STATE OF MICHIGAN
DEPARTMENT OF ENVIRONMENTAL QUALITY
JACKSON DISTRICT OFFICE

SUBJECT: Gelman Sciences, Inc. Remedial Action
Performance Monitoring Plan, Maple Road Interim Response, February 3, 2006
Performance Review, Maple Road Interim Response, July 17, 2006

SUBJECT: Review of System Performance and Performance Monitoring Plan (PMP) – Pall
Life Sciences (PLS) Site, Scio Township

**PERFORMANCE MONITORING
 PLAN FOR MAPLE ROAD
 INTERIM RESPONSE**

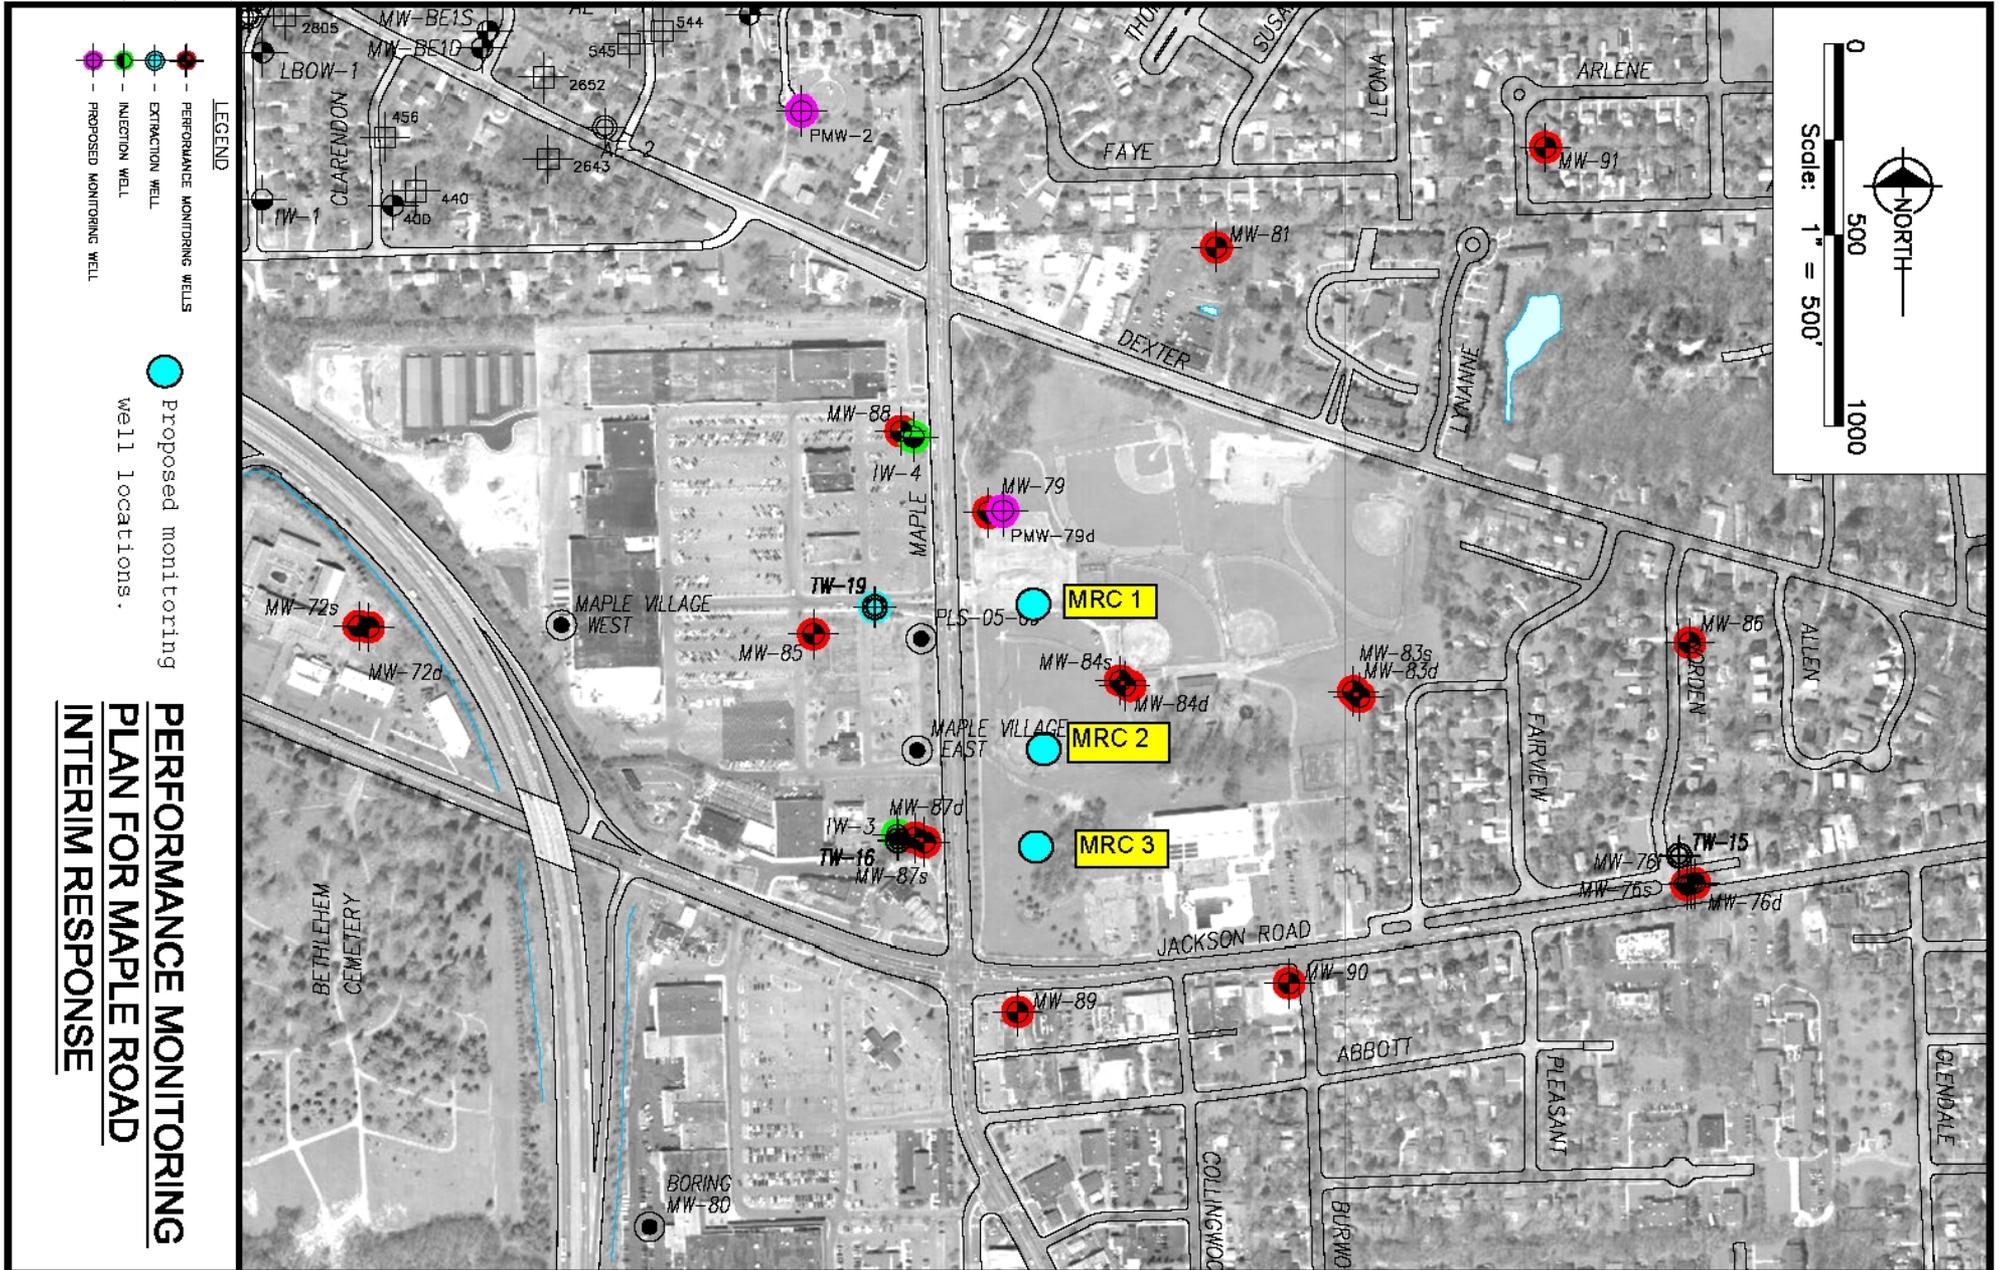
Therefore, as specified by Mr. Mandle, PLS must install three monitoring well nests on the east side of Maple Road at the locations indicated in the attached Figure 1. These borings should be vertically profiled to bedrock and the boring information and vertical profiling results should be provided to us as they become available. PLS must consult with the DEQ prior to deciding on the placement and number of well screens at each location.

Figure 1 in the IPR report shows the location of wells to be monitored as part of the proposed MRPMP. As can be seen on this figure, there are very few wells in close proximity to Maple Road. The distances between the wells nearest to Maple Road are approximately 500 feet between the clusters at MW-79 and MW-84, and approximately 850 feet between the clusters at MW-84 and MW-89. Because of uncertainty in the contaminant migration pathway and the distance between these monitoring wells, we cannot be sure that these wells are placed in the appropriate locations to monitor compliance to the performance standard at Maple Road. It is clear that, if the central part of the 1,4-Dioxane plume is approximately 250 feet as mapped, having wells spaced 500 to 850 feet apart will not be adequate. Collecting groundwater samples from widely spaced monitoring wells that may not be along the plume centerline may not provide an accurate depiction of remedy performance. Additional monitoring wells will be needed along Maple Road to provide data to make timely decisions regarding the operation of the MRIR.

In order to monitor whether the MRIR meets the performance standard at Maple Road, monitoring wells must be placed no more than 250 feet apart along Maple Road. The existing wells are spaced much farther than this or located too far downgradient. It is recommended that vertical profiling of the aquifer be completed at three locations (*MRC 1*, *MRC 2*, and *MRC 3*); midway between MW-79 and MW-84s, and 250 and 500 feet south-southeast of MW-84s. The proposed locations for vertical aquifer profiling are shown on Figure 1. Monitoring well nests should be installed at these locations and completed in the zones of highest 1,4-Dioxane concentration. The vertical placement of well screens should be determined after examination of the vertical profiling data and consultation with Department of Environmental Quality (DEQ) staff. Groundwater sample collection and groundwater level measurement should be performed quarterly in these proposed wells. Wells used to monitor compliance at Maple Road are listed in Table 1.

The three monitoring well nests to be located east of Maple Road should be installed by the end of February 2007. Please seek access for installation of these monitoring well nests and notify us at least three days prior to beginning field work. Please inform us of your intent to install the three monitoring well nests on the east side of Maple Road by December 22, 2006.
